PRODUCT/PROCESS CHANGE NOTICE (PCN)

PCN #: **TB1503-01** DATE: **July 22, 2015**
 Product Affected: **TSSOP-20, TSSOP-24, TSSOP-28,
 TSSOP-48, TSSOP-56, TVSOP-48
 SOIC-28, SSOP-20, SSOP-28,**
 (Refer to Attachment II for affected part# shipped in Reel)
 Date Effective: **November 2, 2015 Earliest Date - Refer to
 specific date by package type**

ATTACHMENT I - PCN #: TB1503-01

Illustration of Carrier Tape Pocket Design Change

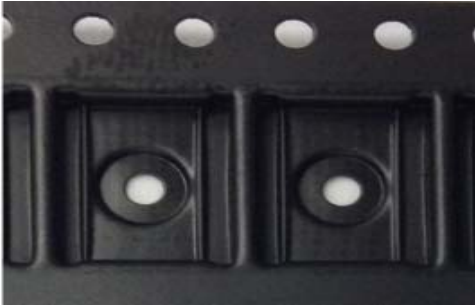
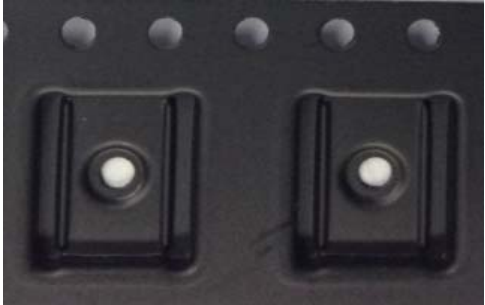
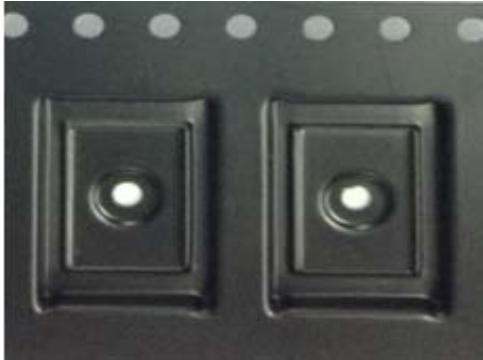
| Package | From | To |
|----------|--|---|
| TSSOP-20 | Carrier Tape Part# P8-464-000  | Carrier Tape Part# P8-291-P20  |
| TSSOP-24 | Carrier Tape Part# P8-329-P24  | Carrier Tape Part# P8-169-P24  |
| TSSOP-48 | Carrier Tape Part# P8-260-P48  | Carrier Tape Part# P8-324-P48  |

Illustration of Carrier Tape Pocket Design Change

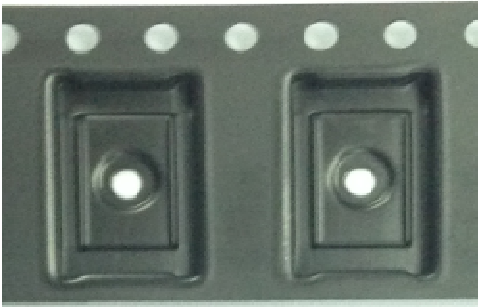
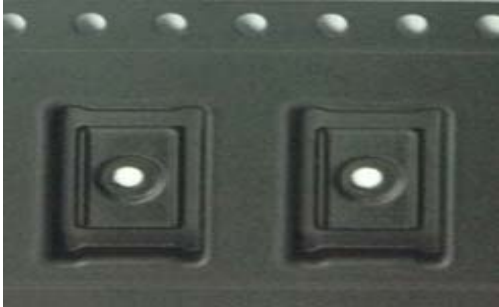
| Package | From | To |
|-----------------------------|--|---|
| SOIC-28 | Carrier Tape Part# P8-187-S28  | Carrier Tape Part# P8-370-P28  |
| TSSOP-28 and TVSOP-48 | Carrier Tape Part# P8-145-PF8  | Carrier Tape Part# P8-330-P48  |
| TSSOP-56 | Carrier Tape Part# P8-261-P56  | Carrier Tape Part# P8-314-P56  |

Illustration of Carrier Tape Pocket Design Change

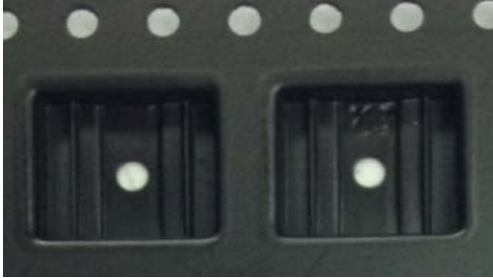
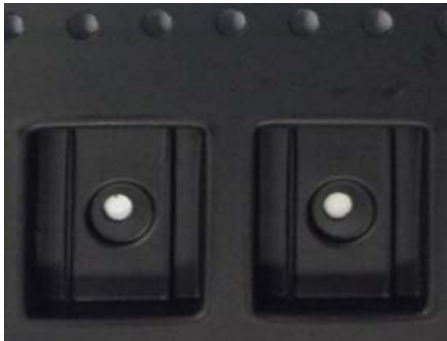
| Package | From | To |
|---------|--|---|
| SSOP-20 | Carrier Tape Part# P8-259-P20  | Carrier Tape Part# P8-320-P20  |
| SSOP-28 | Carrier Tape Part# P8-384-P28  | Carrier Tape Part# P8-321-P28  |
